CASE: PAR220024
EXHIBIT: Exhibit A
DATE: 5/13/2022
PLANNER: R Brady
Meeting Contract Agenda Final

Conceptual Site Plan

Cajalco Rd. and Seaton Ave.

County of Riverside, CA

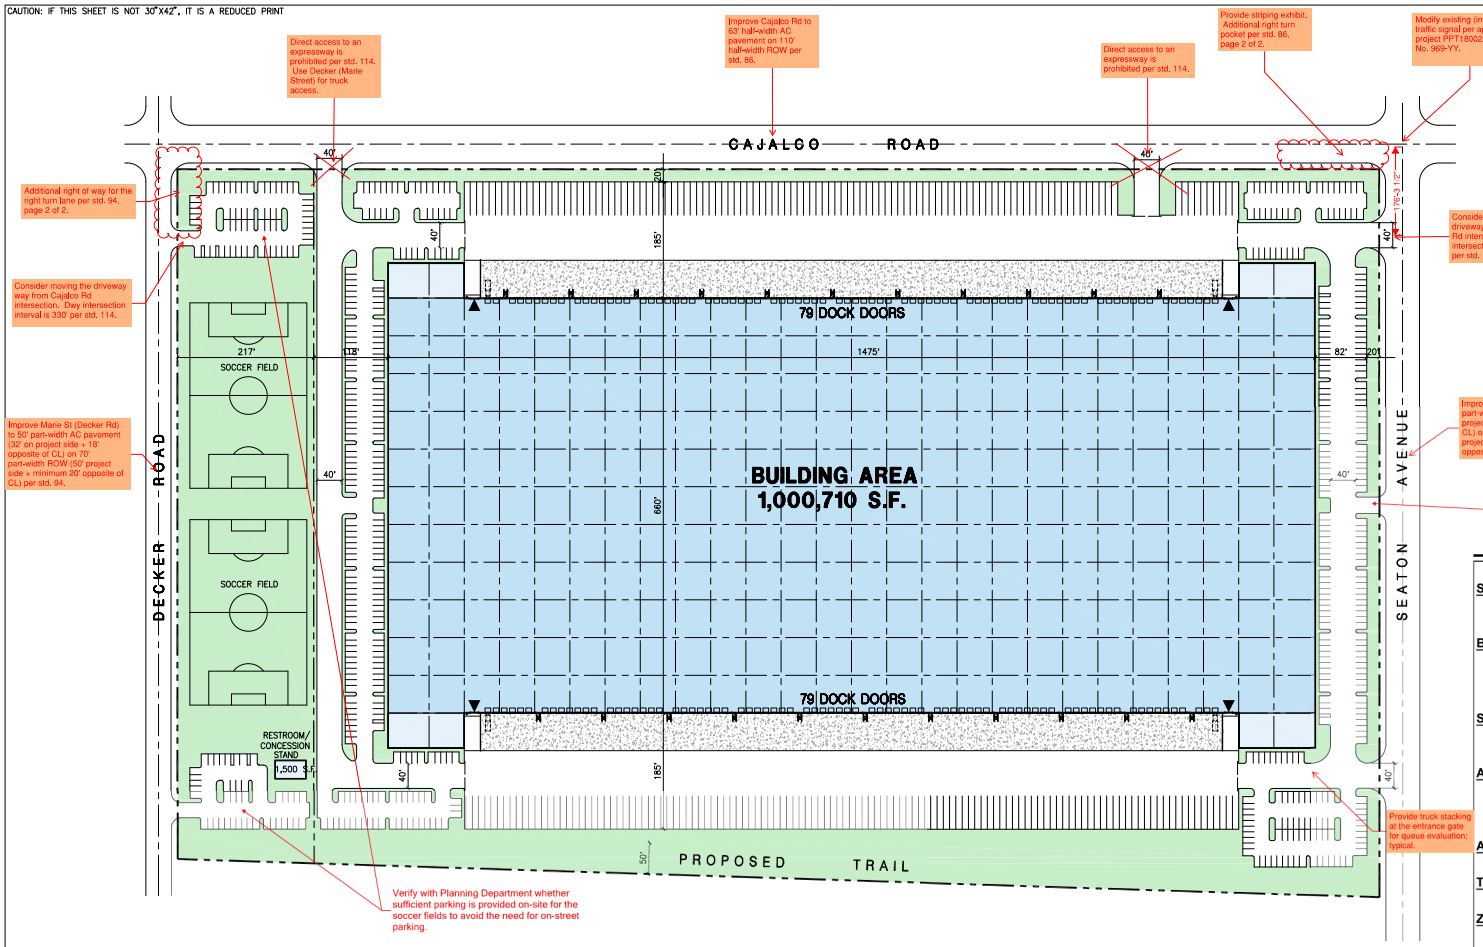
[Transportation Comment]
The truck access needs to be re-evaluated to minimize conflicts with the through traffic on Cajalco Rd. Project access should be taken from Decker Rd or Seaton Ave. More on-site truck queuing is needed to avoid any backup onto the public streets.
